Appendix 1

1. What are the detection limits of the applied in-service inspections regarding hydrogen flakes?

Figure 1 – page 28 of the 2015 Doel 3 Safety Case

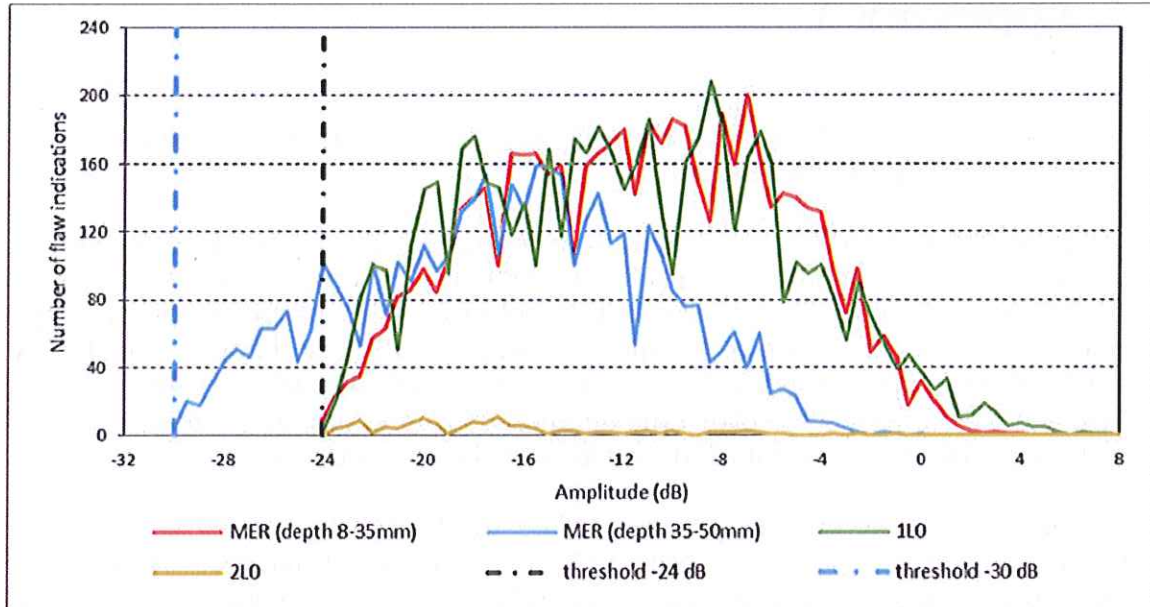
In addition to the demonstration of the detection performance of the UT procedure as achieved by the qualification, an illustration of the capability of the UT procedure to detect nearly the whole population of flakes is provided by the examination of the amplitude distribution curve of the indications (see paragraph 4.2.2 in the 2015 Safety Case¹).

First, the "Gaussian" shape of the amplitude distribution curve for the different transducers conforms to the expectation for a large population of indications. Then and more importantly, for low values of the amplitude, the relationship between the number of indications and the amplitude (dB) is approximately linear. Finding that the left-hand side of the distribution curves is vanishing at the reporting threshold provides therefore additional confidence in the detection capability of the transducers.

Figure 5 – Doel 3 H1 nozzle cut-out and cross section after polishing and etching

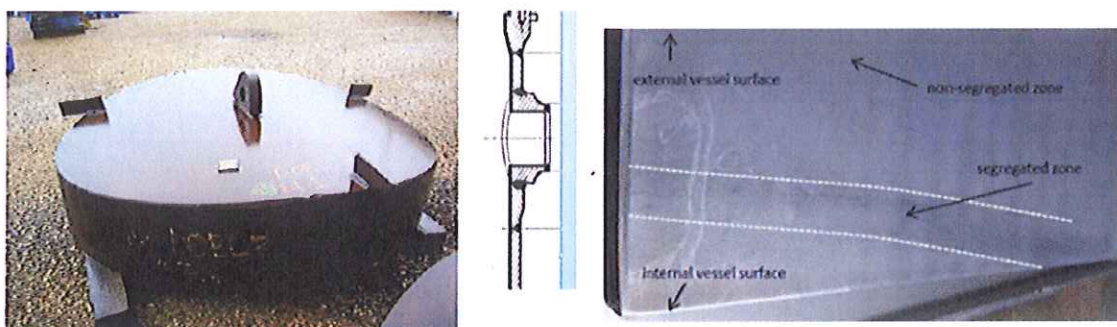
5. How was the degree of the segregations in the forged RPV rings of Doel-3 and Tihange-2 estimated, i.e. their extent and the maximum concentrations?

The size of these nozzle shell cut-outs is of the order of 1.2 m in diameter and 200 mm in thickness. In each component, a zone of macro-segregation was identified after cutting the component in two, polishing and etching of the sections (Figure 6, concerning D3H1).

C-mapping of three nozzle shell cut-outs allowed to determine experimentally the maximum C-enrichments. The measured maximum C-enrichments are 25 % for the D3 nozzle shell cut-out (D3H1), 30% for the T2 nozzle shell cut-out (T2H2) and 24% for the H2BQ3 nozzle shell cut-out.

Figure 6 – Charpy impact energy transition curves KS02 B, non-segregated and macro-segregated areas

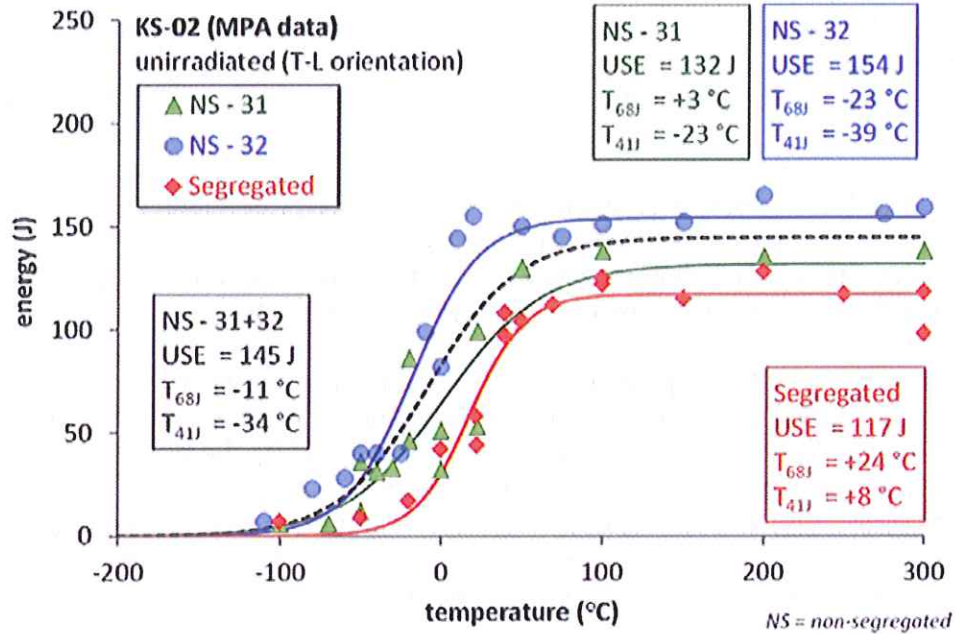
6. How was the influence of the segregations on the fracture toughness of the RPV materials assessed? How were the data from other known cases of pronounced segregations considered (KS02, top head and bottom of RPV for EPR projects)?

In terms of Charpy properties, the difference between macro-segregated and non-segregated zones in KS02 is 31°C or 47°C at 41 J level on the energy curves, depending on the dataset (N° 31 or 32 respectively) used for the non-segregated material (Figure 7). For the lateral expansion data, the curve 31 is even closer to the "segregated" curve and the difference at the 0.89 mm level is only 6 J (less than the experimental uncertainty). The Shear Fracture Appearance data is not available for the "segregated" material so that no comparison is possible for this parameter.

Figure 9 - page 80 of the Doel 3 2015 Safety Case

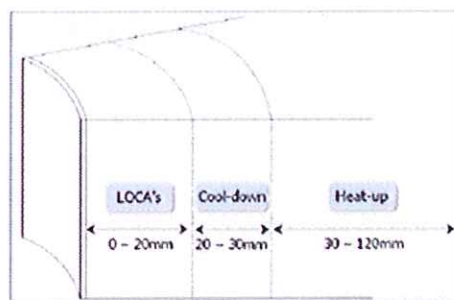
11. What are the load cases considered and how were the structural analyses performed in detail (loads during normal operation, transients and accidental loads, identification of the leading pressurized thermal shock (PTS) - transients, strip/plume cooling or axisymmetric thermal shock, linear-elastic or elastic-plastic material behaviour, consideration of residual stresses due to the cladding process, consideration of inhomogeneous material properties in the segregated areas, assumptions on defects)?

The transients from the Primary System design file were screened in order to determine the driving transients, i.e. the most penalizing transients with respect to brittle fracture, as a function of the position in the wall (ligament S), for the considered case of quasi-laminar flows located in the core of the RPV shell. This screening identified the LOCAs (Loss Of Coolant Accidents) as being the driving transient for the first 20 mm from the cladding (inner side of the vessel wall), while the cool-down transients dominated in the next 10 mm and the heat-up transients in the deeper part of the wall (Figure 6.7).

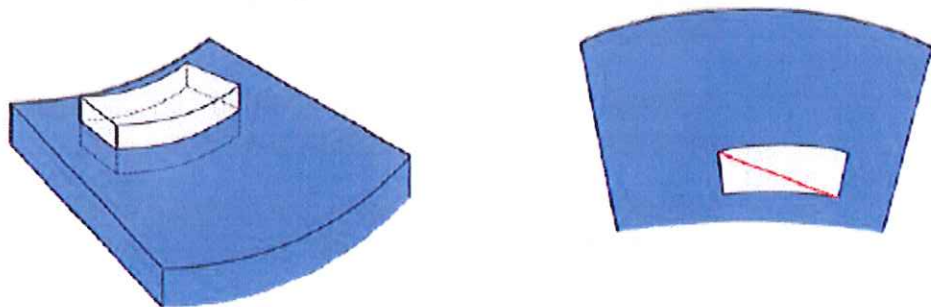
13. For the proof of the structural integrity of the RPV an elastic-plastic analysis of the load bearing capacity according to ASME BPVC Section III, Subsection NB-3228.3 was performed.

The UT provides indications as boxes (white boxes below). The 2D flaw (red line below) is taken as the largest flaw with highest tilt included in the UT box.
